Block 16 Section 10

1.0 Context and Character

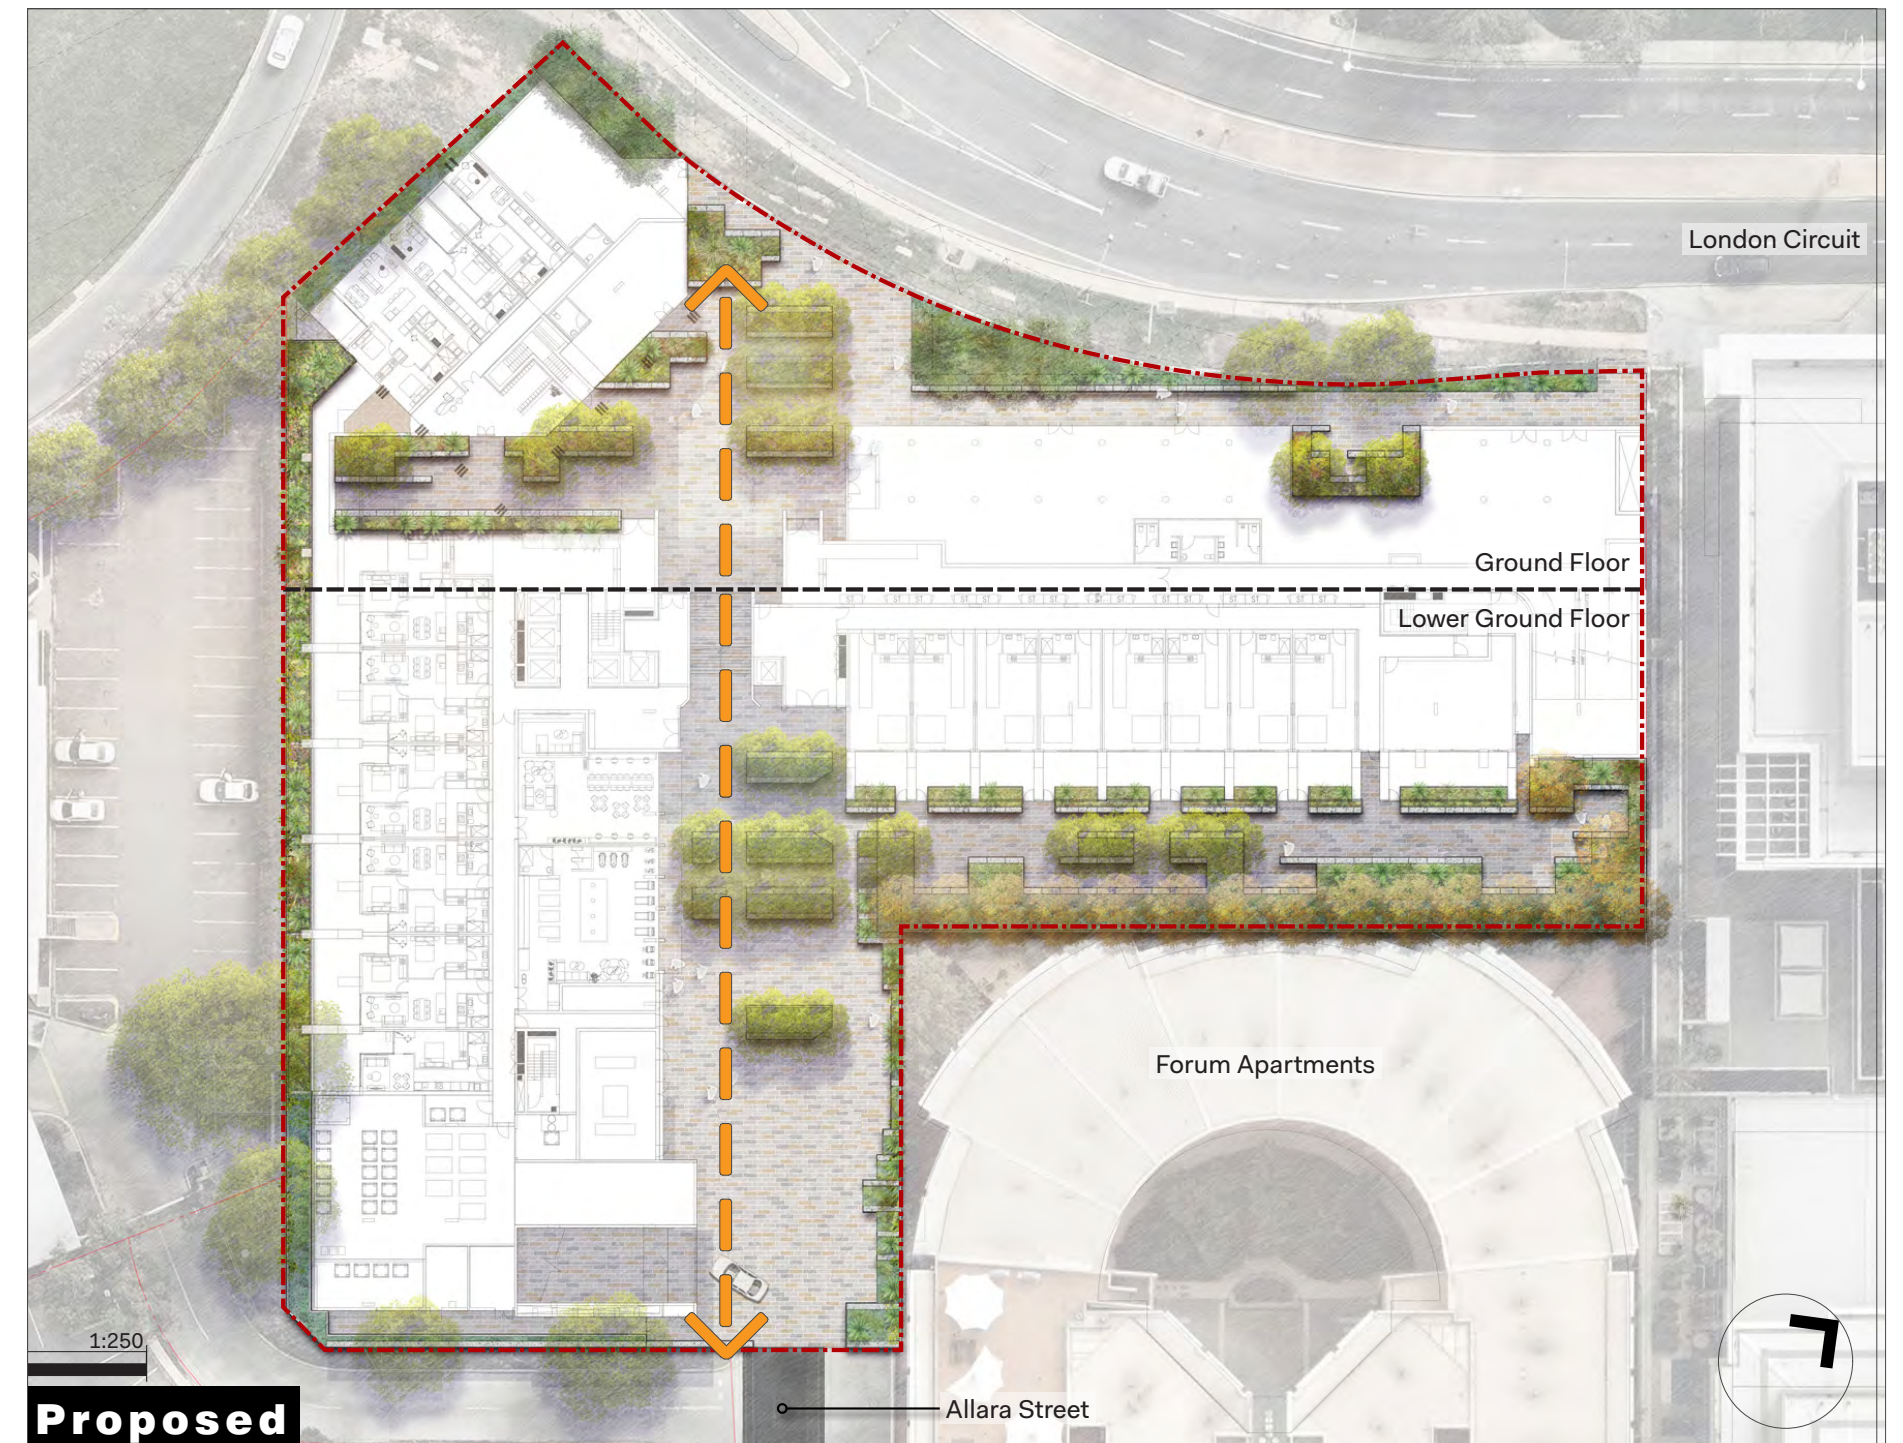
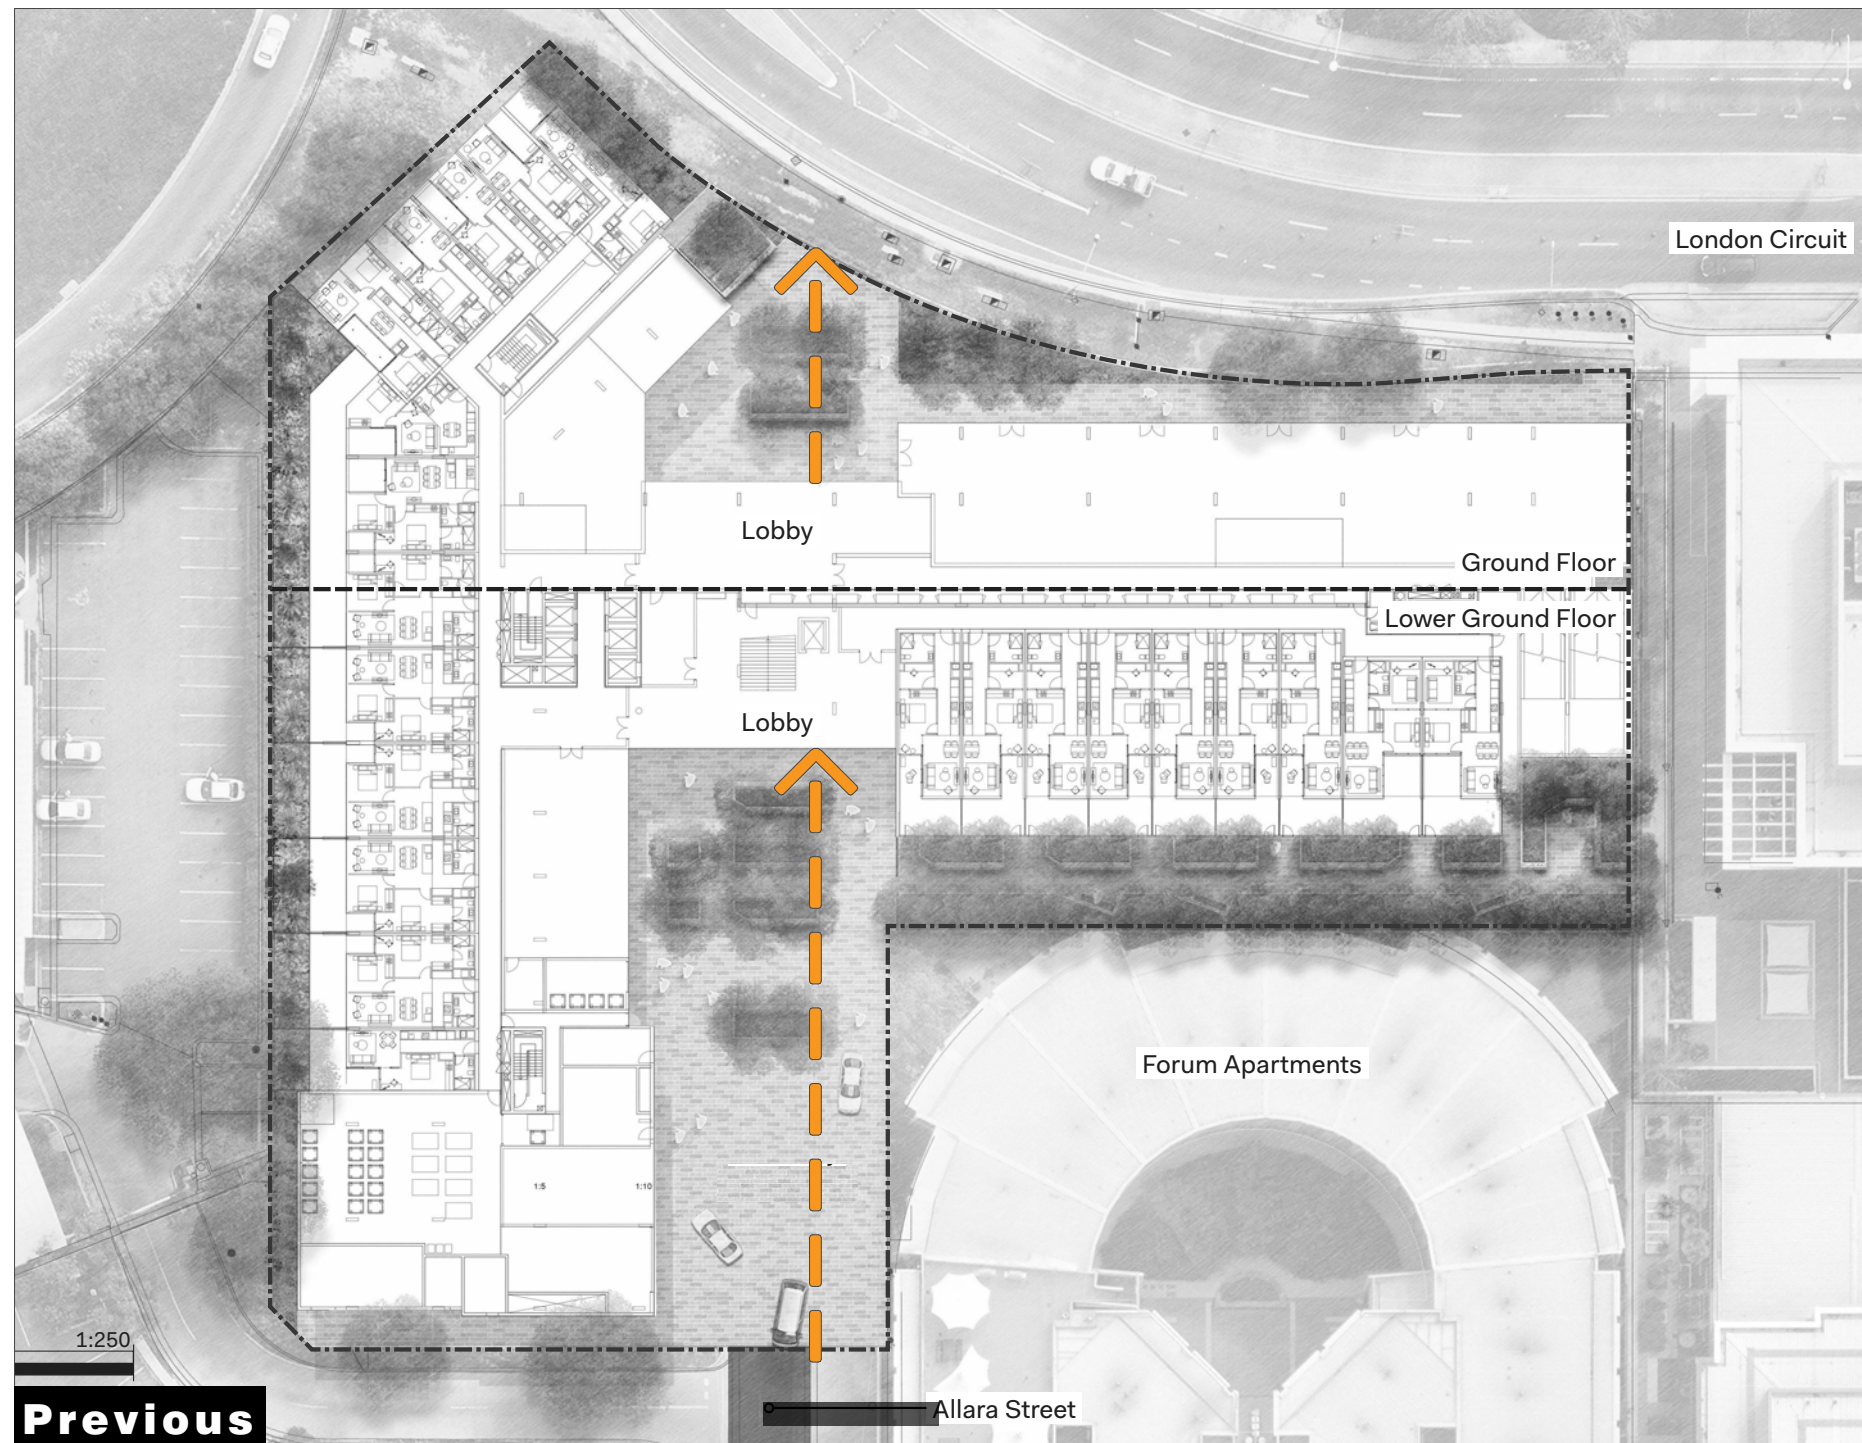
3.1 The Panel considers that the current suitability strategy for the proposal which advocates for performance glazing and apartment heat retention as well as reduced vehicle use is insufficiently robust to achieve acceptable living outcomes for occupants. The Panel acknowledges the proponent assessment of the Canberra environment as a predominantly cold climate; however, the Panel advocates that external shading devices and adequate cross flow ventilation is considered for the development. Furthermore, the Panel acknowledges that although apartments are a typically 'lower emission' dwelling types than corresponding numbers of single dwelling housings, the Panel does not consider all apartments developments to be inherently sustainable. As such, the Panel strongly recommends that the proponent team interrogates opportunities for

Built form and scale Built form

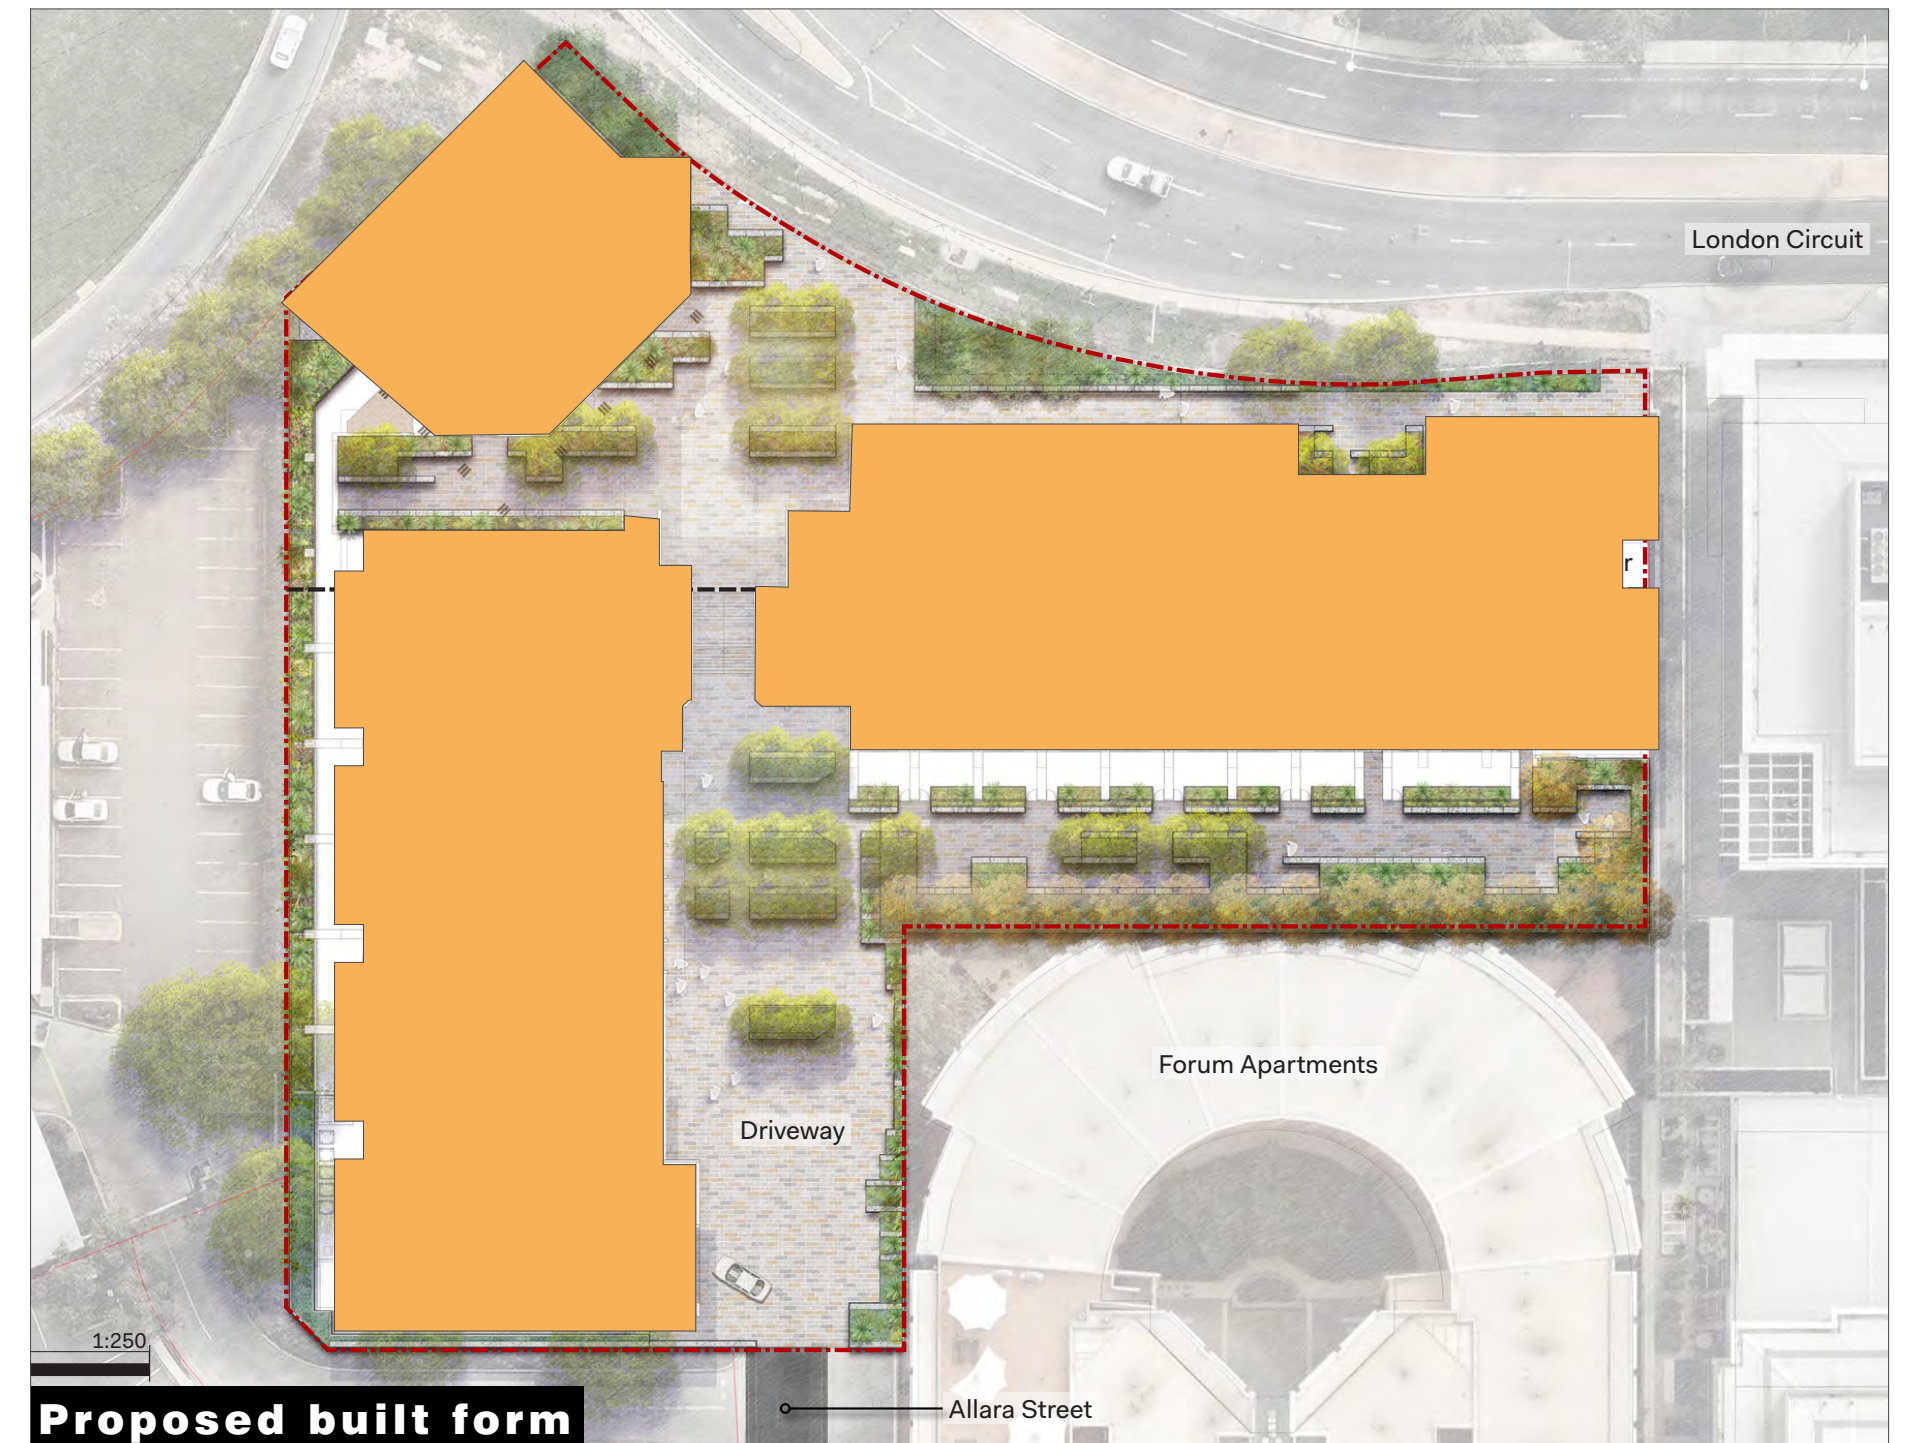
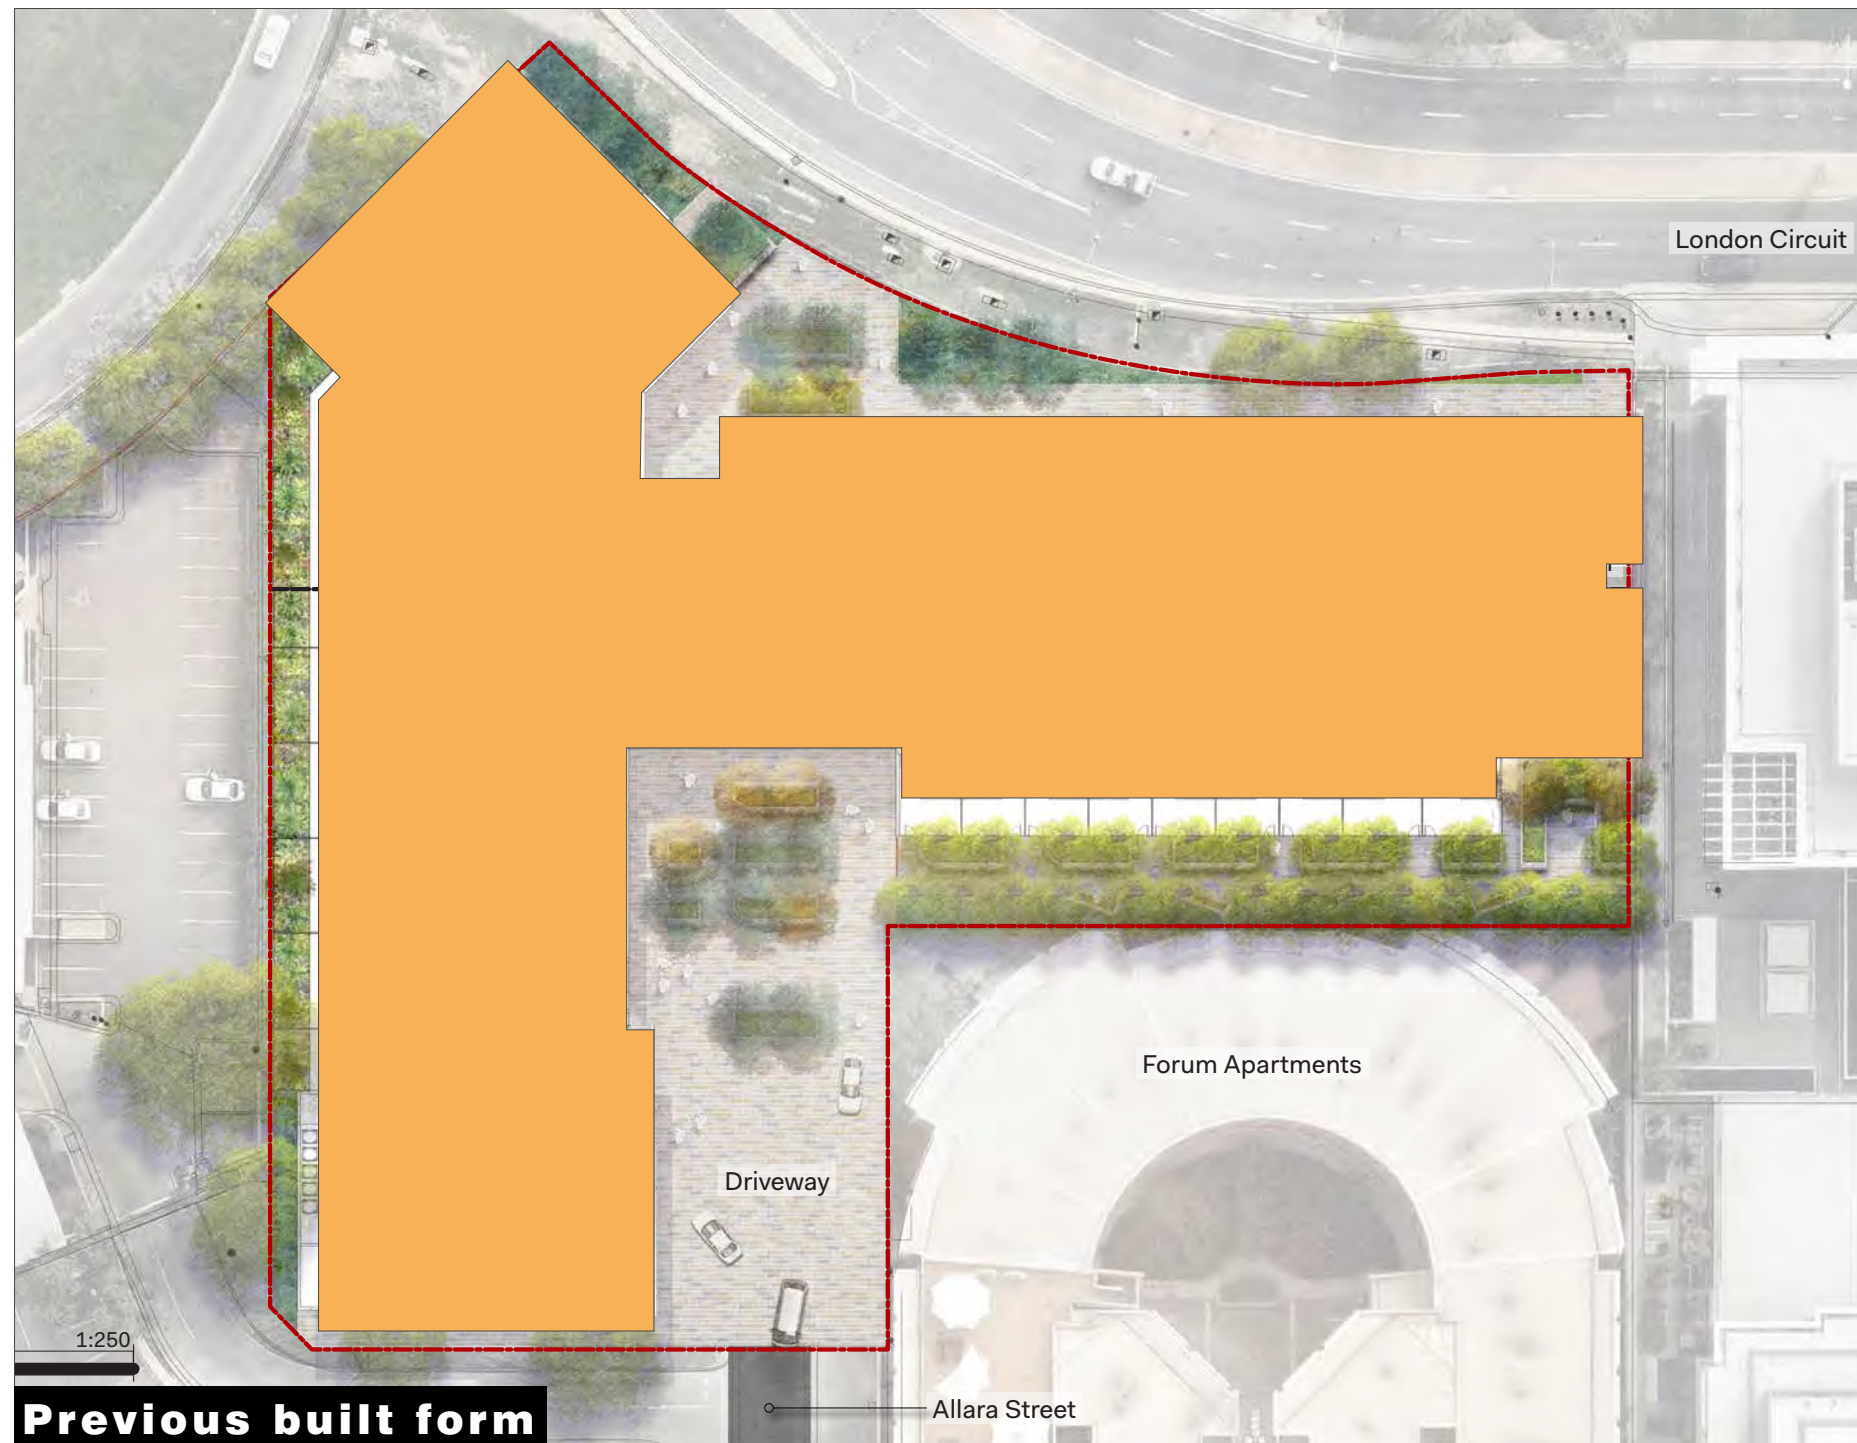
5.1 Acknowledging the length of Building 1 proposed to London Circuit has precedent on London Circuit developments, the Panel considers that it is not the predominant condition. As such, the Panel considers the current building mass and bulk to London Circuit would benefit from further design development to provide a greater level of articulation, site permeability and creation of inner urban space as a means to break down the current building bulk. This may include consideration of multiple and separate building forms, central and peripheral open access ways and more generous public courtyards. The Panel therefore recommends the proponent team investigate how the preliminary building form alignment diagram could be reinterpreted to provide an alternate outcome for the development.

5.2 The footprint of the proposed building form is considered by the Panel to be heavy and impeding the quality of the overall development. As such, the Panel recommends the proponent team reconsiders the current floorplate depth as an opportunity to create generous public and common open central courtyard spaces, similar in character to other Sections around London Circuit.
